Certificate of Appropriateness

Milwaukee Historic Preservation Commission/841 N Broadway/Milwaukee, WI 53202/phone 414-286-5712

Property 2731 N. Grant Blvd
Description of work Repair/reconstruct brick chimney. Details as attached on pages 3+, excepting conditions on this page.
Date issued 4/16/25

CHIMNEY DOCTORS POURED CONCRETE CHIMNEY CAP

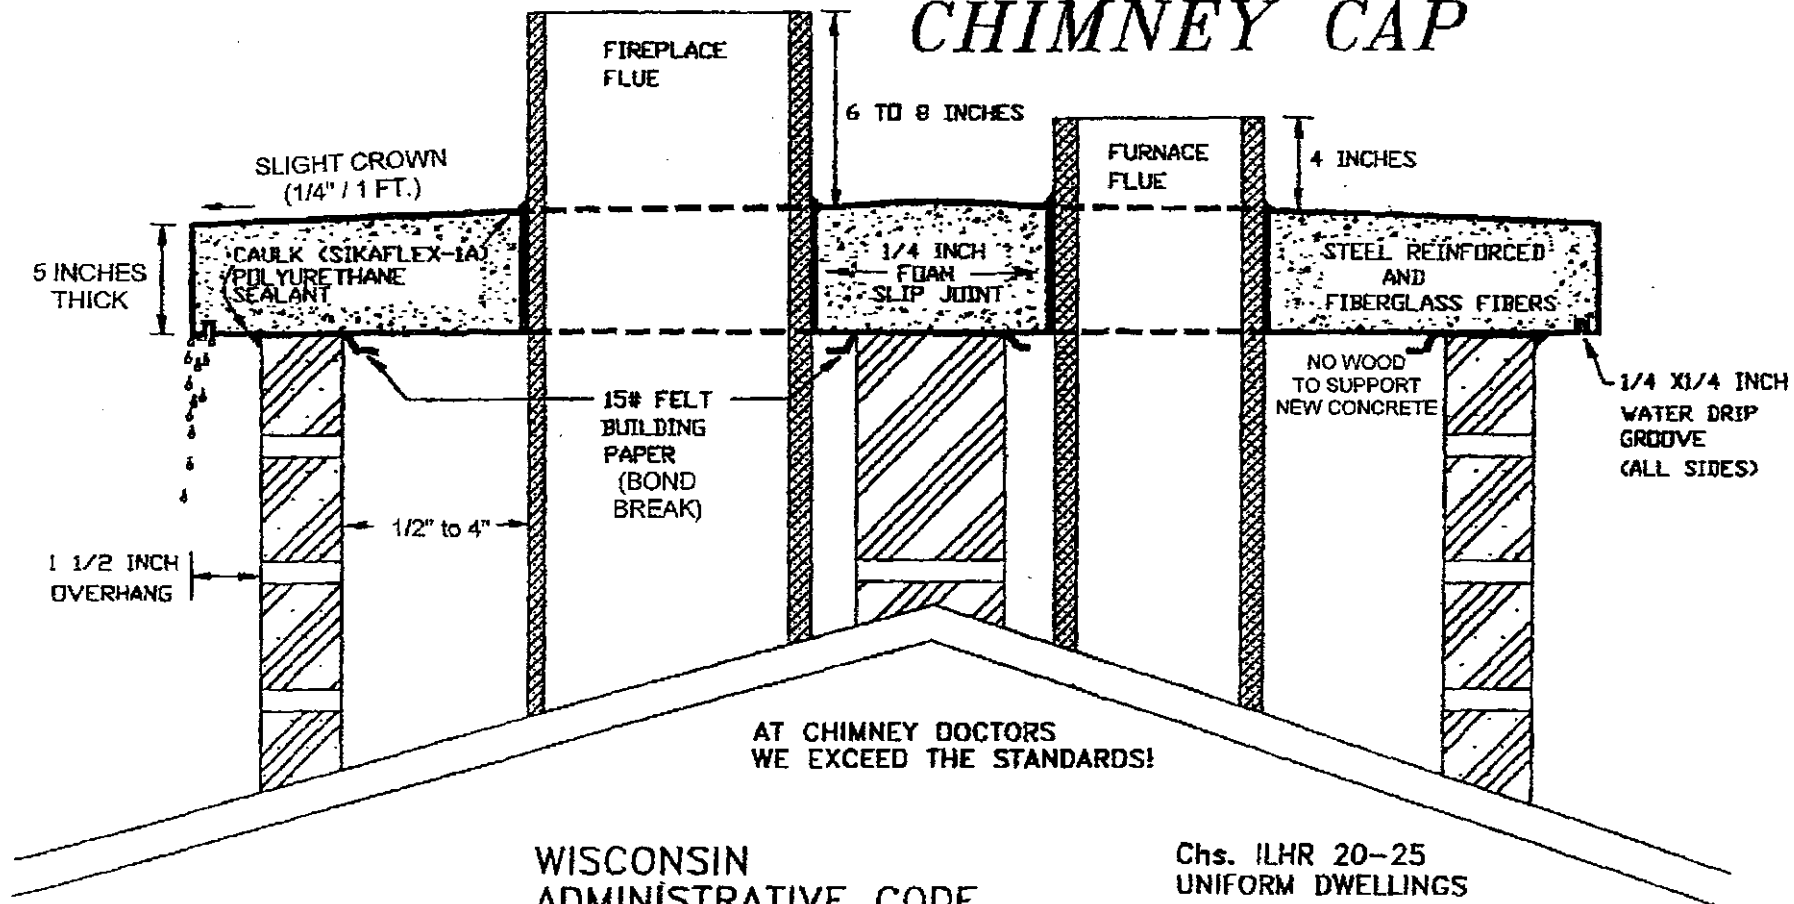
TYPE S MORTAR IS PROHIBITED. USE NOTHING HARDER THAN TYPE N FOR CONTACT WITH BRICK, LIME-BASED MORTAR IS STRONGLY RECOMMENDED. CEMENT FOR LINING IS NOT RESTRICTED.

UNDER NO CIRCUMSTANCES SHALL UNPAINTED MASONRY BE PAINTED, BE GIVEN A WATERPROOFING TREATMENT, OR CLEANED BY ABRASIVE MEANS; THIS STATEMENT SUPERSEDES ANY OTHER WORDING IN THIS DOCUMENT INDICATING THE CONTRARY.
